TSG-RAN Meeting #12
Stockholm, Sweden, 12 - 15 June 2001

TSGRP#12(01) 0381

Title: Agreed CRs to TS 25.427

Source: TSG-RAN WG3

Figure 11: Uplink data frame structure

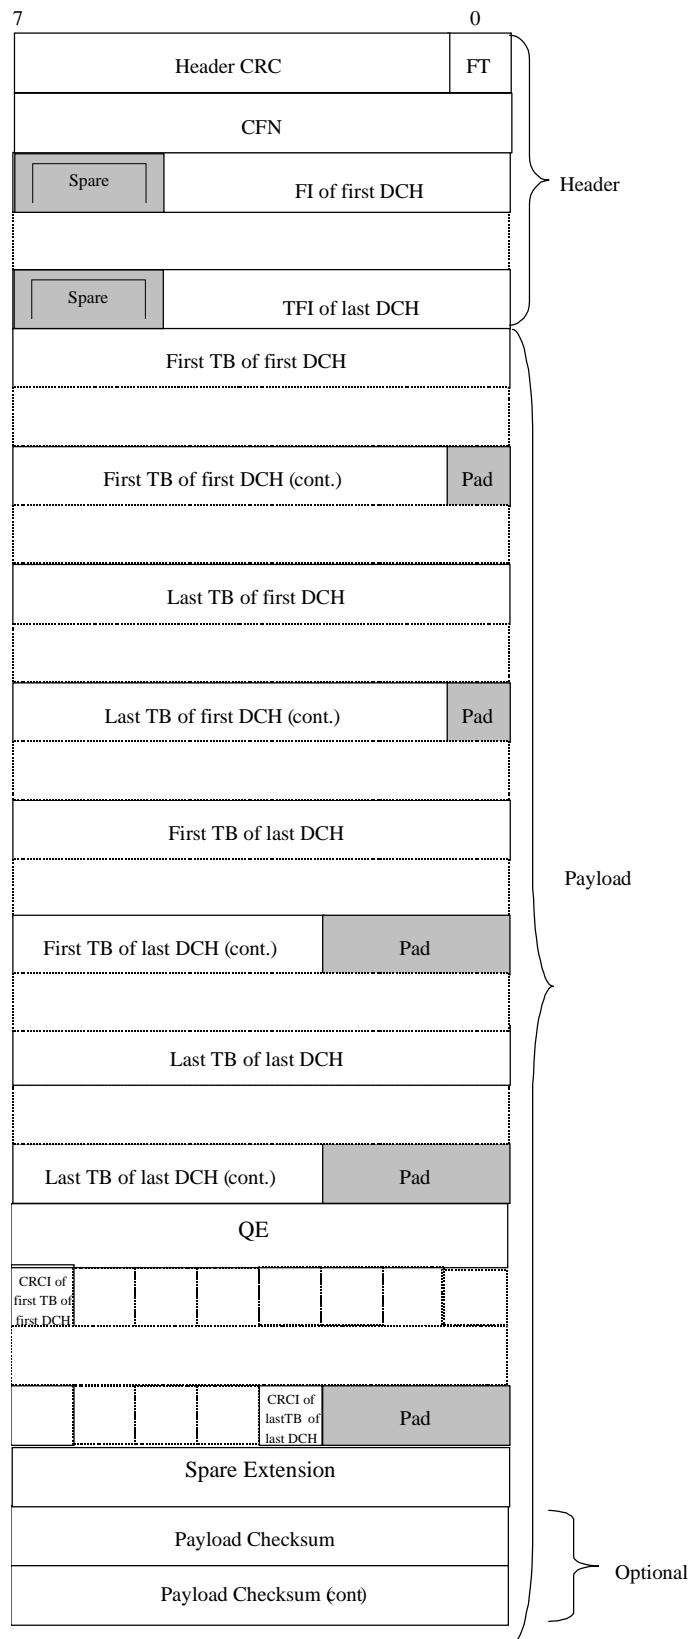
Reason for change:	⌘ The current specification version states that there is a CRCI bit for each TB included in the frame. But it is not clearly indicated if the CRCI bit is included if the size of the TB is zero.
Summary of change:	⌘ This CR adds a clarification that the CRCI bit is included also for TBs with TB length equal to zero.
Consequences if not approved:	⌘ If this CR is not approved there is a possibility for different interpretations and problems might occur in a multivendor environment. This CR is backward compatible.

There is a CRCI for each TB included in the frame irrespective of the size of the TB, i.e. the CRCI is included also when the TB length is zero. If the CRC indicators of one data frame do not fill an integer number of bytes, then bit padding is used as shown in the figure in order to have the octet aligned structure (ex. 3 CRCI bits require 5 bits of padding, but there are no CRCI bits and no padding, when number TBs is zero).

Figure 11: Uplink data frame structure

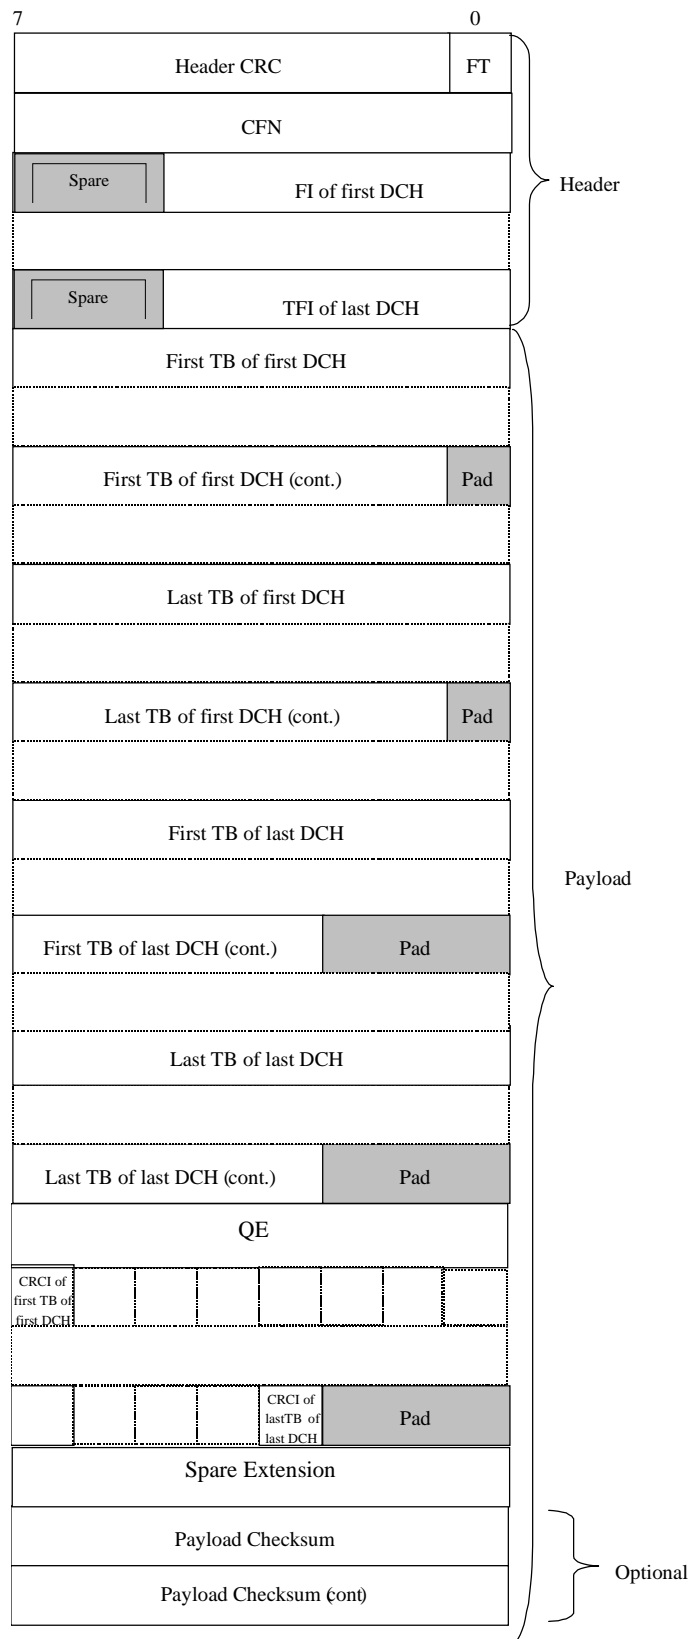
Reason for change:	⌘ The current specification version states that there is a CRCI bit for each TB included in the frame. But it is not clearly indicated if the CRCI bit is included if the size of the TB is zero.
Summary of change:	⌘ This CR adds a clarification that the CRCI bit is included also for TBs with TB length equal to zero.
Consequences if not approved:	⌘ If this CR is not approved there is a possibility for different interpretations and problems might occur in a multivendor environment. This CR is backward compatible.

There is a CRCI for each TB included in the frame irrespective of the size of the TB, i.e. the CRCI is included also when the TB length is zero. If the CRC indicators of one data frame do not fill an integer number of bytes, then bit padding is used as shown in the figure in order to have the octet aligned structure (ex. 3 CRCI bits require 5 bits of padding, but there are no CRCI bits and no padding, when number TBs is zero).
